From: BRYAN Martin (EXT)
Sent: Tuesday, July 20, 2010 5:07 PM
To: 'Tesfaye, Getachew'
Cc: DELANO Karen V (AREVA NP INC); ROMINE Judy (AREVA NP INC); BENNETT Kathy A (OFR) (AREVA NP INC); NOXON David B (AREVA NP INC)
Subject: Response to U.S. EPR Design Certification Application RAI No. 382, FSAR Ch. 19 - PHASE 4 RAI, Supplement 1

Question 19-336:**Follow-up to RAI 133, Question 19-243 (OPEN ITEM)**

The response to RAI 133, Question 19-243, includes as Appendix A the OSSA Methodology Technical Basis report. The staff has reviewed this document. In order to complete its review, however, the staff needs some additional information as follows:

The Operating Strategies for Severe Accidents Methodology for the U.S. EPR™
Technical Report

Figure 4-3—One Common Entry to OSSA from EOP with COT Available

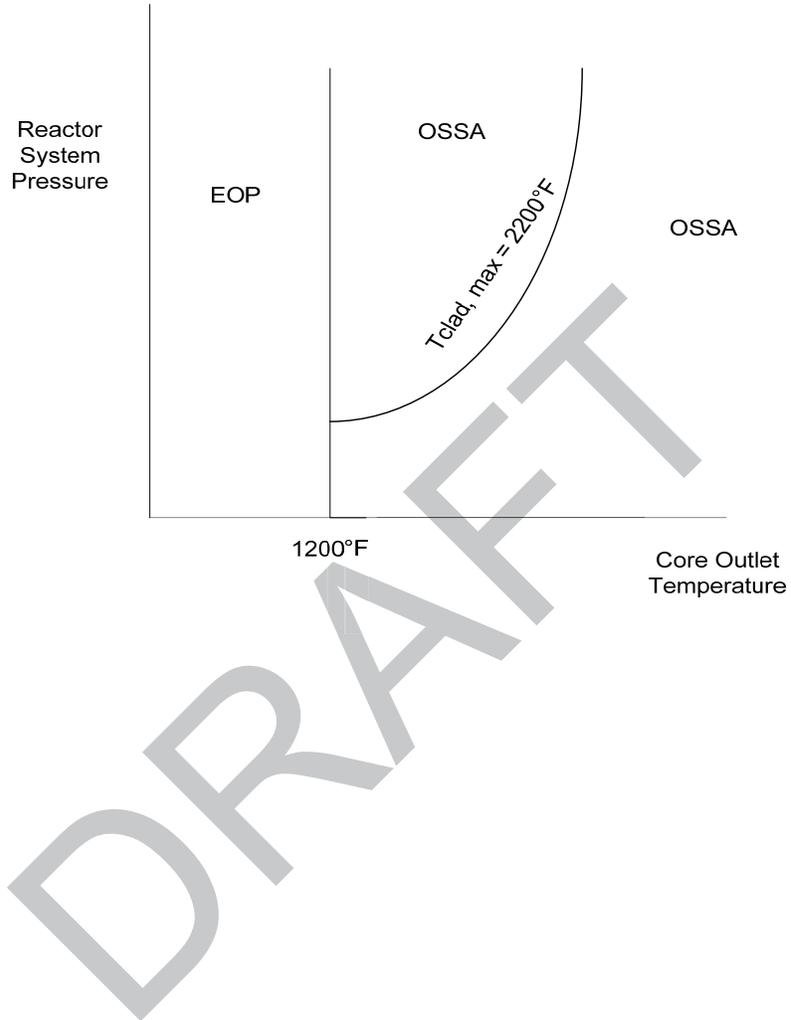
- e. A correlation between primary system pressure, core outlet temperature, and maximum clad temperature, to determine entry into OSSA is mentioned in Section 4.3.1. Please provide details of the correlation, and define its limits of applicability.

ANP-10314 includes information to address this question. Section 4.4.6, Entrance/Exit Criteria Assessment, describes an OSSA task that includes the development of an OSSA entrance criteria correlation. OSSA tasks support the COL applicants. OSSA customer end products are provided to the COL applicants, including the entrance criteria assessment, to aid them in their development of plant-specific SAMG.

reactor system pressure and core outlet temperature are extracted when the predicted maximum clad temperature reaches 2200°F. These data points are then fit into a curve similar to Figure 4-3.

Complicating this objective is that instrumentation may only be rated to a given temperature for a set time. The early OSSA phase recognizes that the keystone operator action of primary system depressurization may provide alternative recovery strategies; therefore, plant control remains with the acting main control room staff. An alternate entry into the OSSA Phase 2, and the involvement of the TSC, must also consider at-power and shutdown operating modes and the instrumentation available and their survivability characteristics. Figure 4-4 shows the entry into the OSSA domains as a function of both RCS pressure and core outlet temperature. OSSA Phase 1 is entered from EOP when the core outlet temperature is greater than 1200°F (650°C).
